Water Compliance Inspection Report

Water Compliance Inspection Potomac Electric Power Company Benning Road Generating Station NPDES No. DC0000094 Inspection Summary

NPDES Compliance Evaluation Inspection NPDES No. DC0000094 Potomac Electric Power Co (PEPCO) - Benning Generating Station, 3400 Benning Road, NE, Washington, DC 20019

Inspection Date: June 3, 2009

Photo 1: New skimmer for the oil/water separator at Outfall 201.

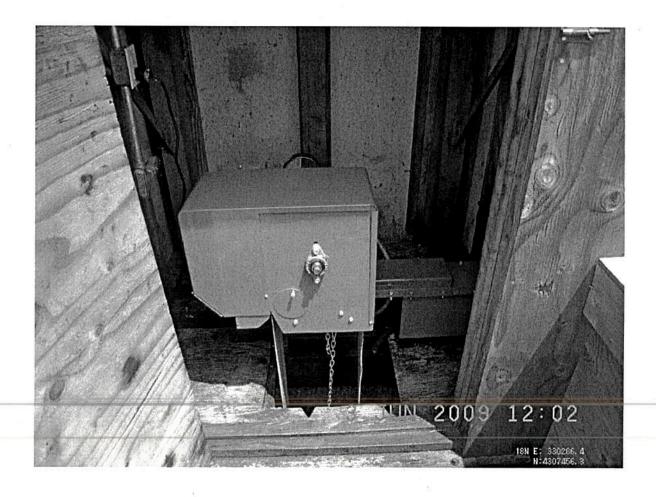
The facility has two oil/water separators: (i) oil/water separation/settling system at Outfall 201, which was designed to remove oil and grease from utility wastewater and an oil 2 loading area. Monitoring point 201 is the discharge point from this oil/water separator (photos 1 & 2). (ii) oil/water separation/settling/filtration system at Outfall 003, which is a treatment system designed to remove oil, grease and solids from water that is removed from utility manholes. The treatment system operates in batch mode and consists of an oil/water separator, settling tank (photo 3 & 4) followed by a two staged filter system of cloth and charcoal media (photo 5). If necessary, pH is adjusted before discharging. At the time of the inspection, the treatment system was operating but not discharging to 003.

Outfall 201: The inspectors observed the general oil/water separator and Outfall 201, which is a monitoring point for the facility's industrial wastewater before it commingles with stormwater and their other process wastewater flows that would discharge to the site's previously noted main storm drain (36" to 54" pipeline). Monitoring point 201 is an internal monitoring point/outfall that discharges intermittent (pump) flow to a manhole on a 48" section of this main pipeline. After the wastewater streams commingle, the effluent flows through a 54" section of the main

A new oil skimmer is installed at Outfall 201. An additional treatment/storage tank was installed at Outfall 003 (oil/water separator).

Photo 4: Skimmer and settling tanks at the oil/water separator at Outfall 003.

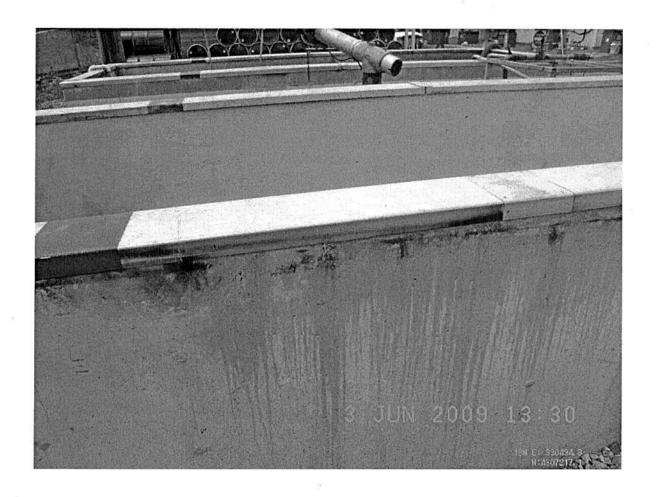
- separator, settling tank (photos 3 &4) followed by a two staged filter system of cloth and charcoal media (photo 5).
- Monitoring point 013 has two sets of monitoring requirements and effluent limits. These
 requirements vary depending on whether there is a discharge of cooling tower blow
 down.
- 3. Monitoring point 201 is the discharge point from an oil/water separator designed to remove oil, grease from utility wastewater.
- 4. Monitoring points 202 and 203 have two sets of monitoring requirements and effluent limits. These requirements vary depending on whether there is a discharge of cooling tower blow down or cooling tower wash water. There was no discharge during the inspection.

Photo 7: Oil boom/filter cloth inside an inlet at Outfall 416. (Typical @ several inlets.)

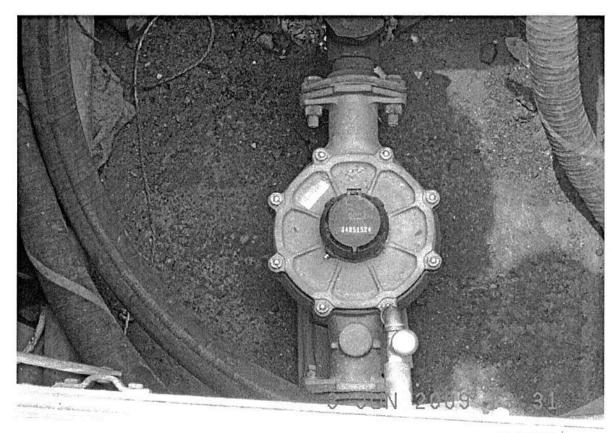
Stormwater runoff from PEPCO is conveyed through a drain system and is discharged to the Anacostia River and city storm sewers at various outfalls. The majority of the stormwater runoff from the service center is conveyed through a 36-inch to 54-inch storm drainpipe to the Anacostia River via Outfall 013 (photo 6). The facility also has two Stormwater Quality Control Structures for controlling sediments (sand, gravel, etc). The facility has housekeeping procedures and BMPs that were in place to prevent release of pollutants to environment. These include: adequate dikes and secondary containment; spill containment and clean-up; oil absorbent booms/filter cloth at inlets/drains (photo 7).

Outfalls 402 and 416: These are internal stormwater inlets receiving no flow at the time of inspection. The outfalls had oil booms and filter cloth inside and appeared to be in good
